CITY OF ANN ARBOR
WATER TREATMENT SERVICES

Re: Addendum to the Contract Documents for the Barton Dam Concrete Testing and Access System, Bid No. ITB-4066

**ADDENDUM NO. 2
TO
BID DOCUMENTS
FOR
BARTON DAM CONCRETE TESTING AND ACCESS SYSTEM
FOR THE
CITY OF ANN ARBOR, MICHIGAN**

**ADDENDUM 2
TYPICAL CROSS SECTION**

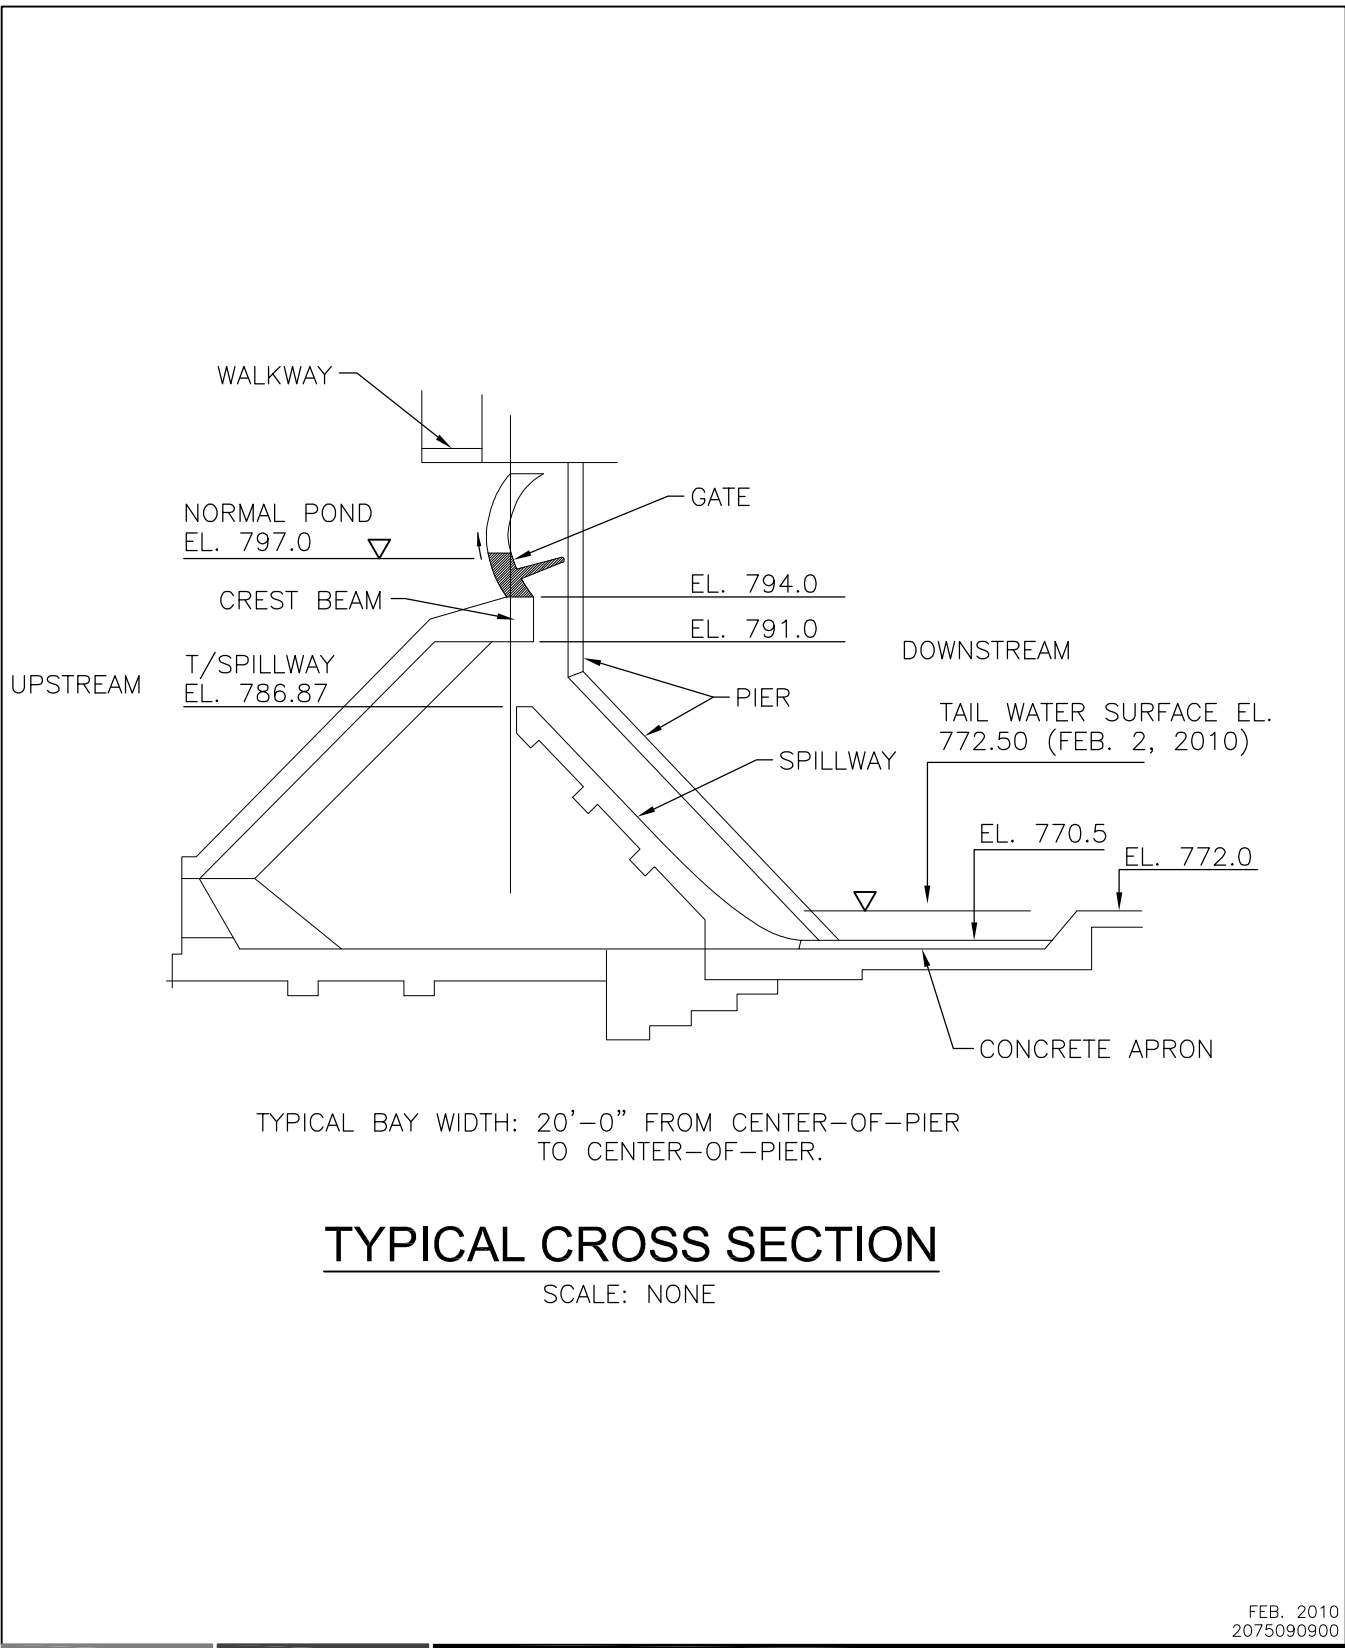
The water surface elevation of the downstream tailrace fluctuates seasonally and due to rain events. Between the months of April and September, the tailrace elevation can fluctuate from approximately 772.50 to 777.00 ±. It was noted on February 2, 2010 that the water surface elevation was only 6-inches above the concrete near the end of the concrete apron. A cross section sketch is attached for reference. This information is being provided for consideration in developing means and methods to access the downstream face of the dam. The Contractor shall be prepared to accommodate the range of the tailwater. No guarantee is expressed or implied as to the water surface elevations.
